From:
Sent: 24 March 2026 20:37
To: Louise Bearcroft; DC Admin
Subject: Subject: Objections Planning Application: 2025/61/92713 and 2025/44/92737

The above application has recently received additional information/amendments.

Interpretation of Policy BE12

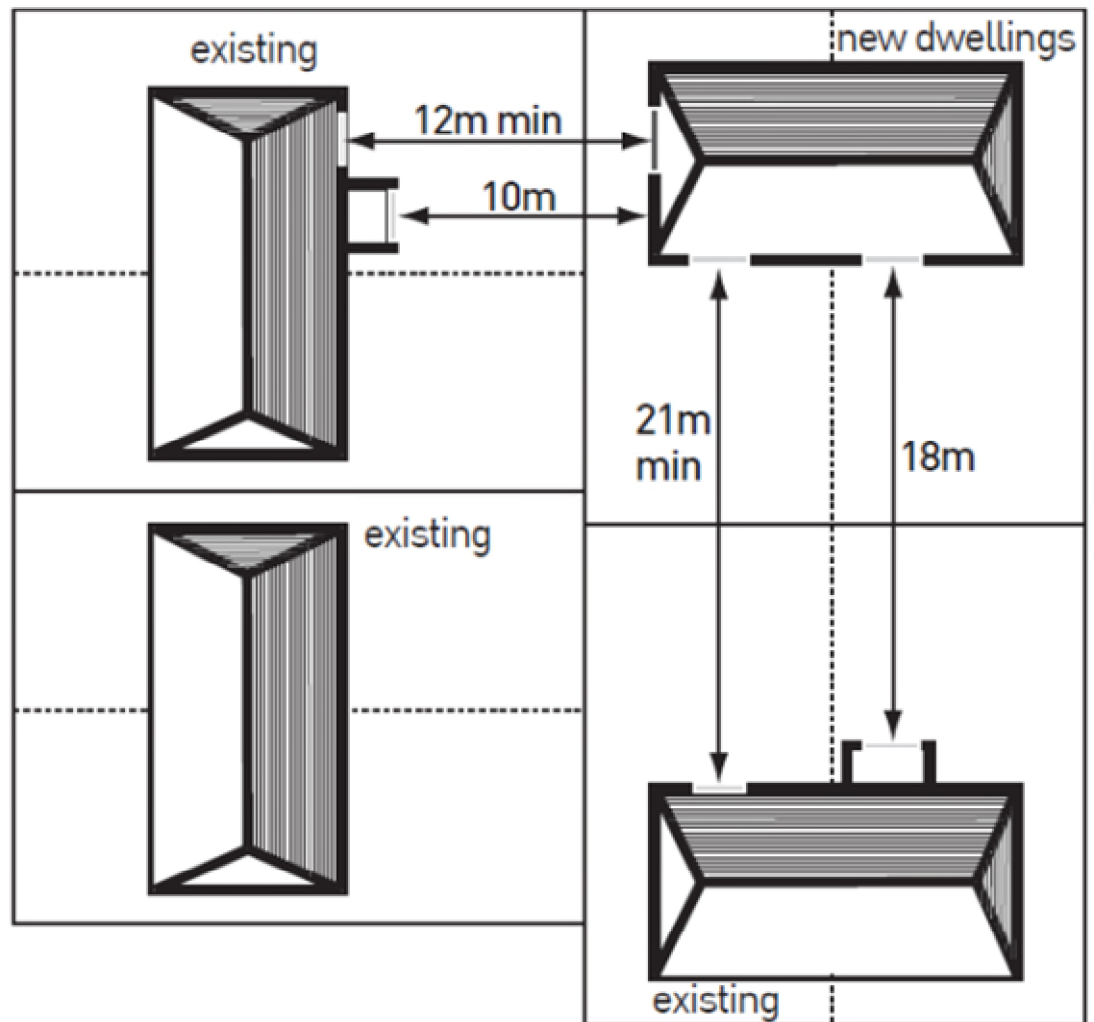
The following diagram was submitted with the above report to Planning Sub Committee members to clarify the interpretation of BE12

Kirklees Planning, on this planning application, is not adhering to their own interpretation, (shown above) that they supplied to Sub-Committee members to follow.
